August 13, 2025

Re: 2025.07.17 Broadway and South Union Street Improvement Project Public Meeting

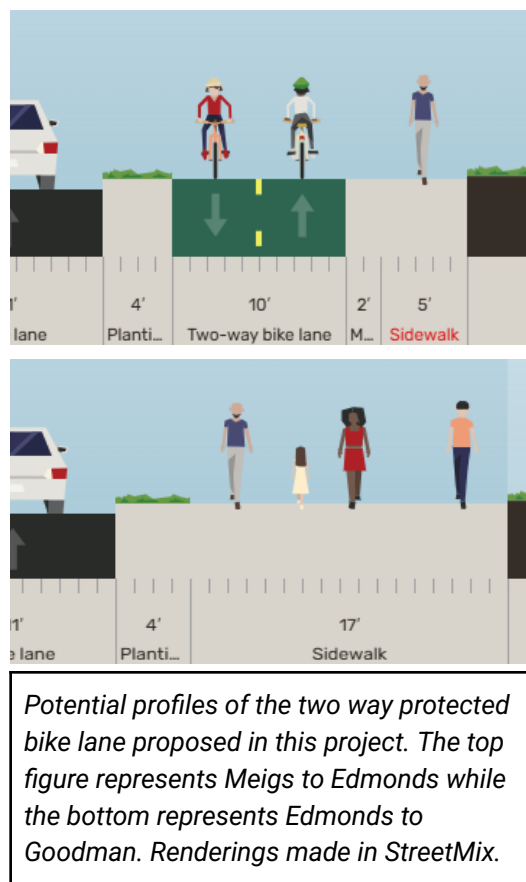
Designers have indicated that bike accommodations would shift from protected to on-street after Pearl Street to preserve several parking spaces. 3 of the 6 buildings on this block have off street parking and ample street parking exists on Pearl Street, Griffith Street, and the surrounding neighborhood. **On roadways identified as part of Rochester's bike network, connectivity and all-ages-all-abilities infrastructure must be the city's number one priority.** The need for parking can be supplemented here by making Griffith Street one way, as recommended by the project team, and allowing parking on both sides of the street (10' travel lane with two 8' parking lanes). We would

also recommend the exploration of a bump out at the intersection of Griffith and Union to shorten the pedestrian crossing distance and protect vehicles parked on the street.

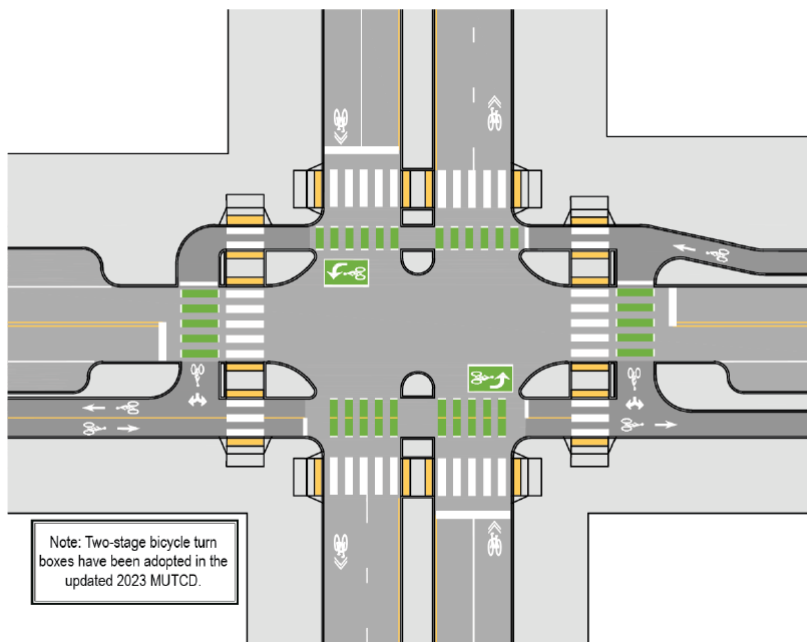
higher cost, and more permanent nature, capital improvement projects should also incorporate the preferred design features such as sloping curb medians instead of flexible delineator posts and pavement markings, and protected intersections instead of mixing zones” (AASHTO Bike 7.2.1).

Figure 7-35 from the 2024 AASHTO Bike Guide depicts a transition between a One-Way and Two-Way Separated Bike Lanes at a protected intersection. We strongly encourage designers to include this configuration or the configuration in figure 7-36 (included in our [previous letter](#)) at the intersection of Meigs and Broadway.

Figure 5-20 from the 2024 AASHTO Bike Guide depicting a Raised Side Street Crossing.

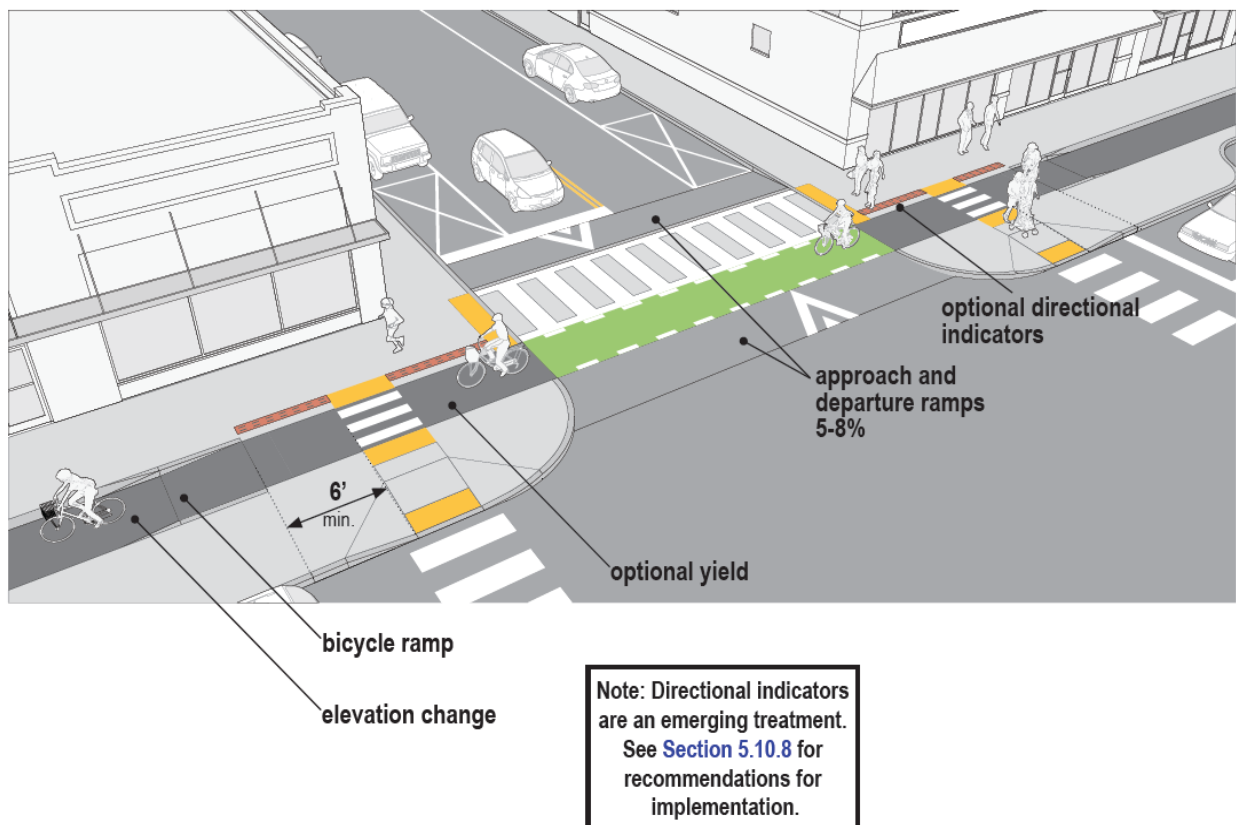
We encourage the project team to evaluate **Raised Crossings** (sometimes called **continuous sidewalks**) at all **unsignalized intersections and driveways in the project area**. Raised crossings keep the sidewalk and protected bike lane at the sidewalk level across side streets. These act as natural speed bumps and “are an effective strategy for reducing crashes between motorists and bicyclists because they slow the turning speed of motor vehicles, increase the visibility of vulnerable street users, and increase yielding behavior of motorists” (AASHTO Bike 5.10.5). One street in Cambridge, Massachusetts, found motorists [yield rates jumped from 10% to 55%](#) following installation. [Research by Ekman and others](#) has concluded that raised crosswalks at unsignalized crossings can be more effective than other traffic control devices because they control speed at the actual pedestrian crossing.

Raised crossings are already standard at driveways in Rochester; however, we recommend exploring them at the intersections of Griffith Street, Pearl Street, Edmonds Street, and Broadway/Union. While this complicates storm water management, reconstruction projects are the time to install raised crossings since waste water infrastructure will likely already be upgraded as part of this project. **We also recommend that project designers examine curb extensions at side streets** to encourage slower turning movements, shorten the pedestrian crossing distance, and to protect parked cars on these streets.
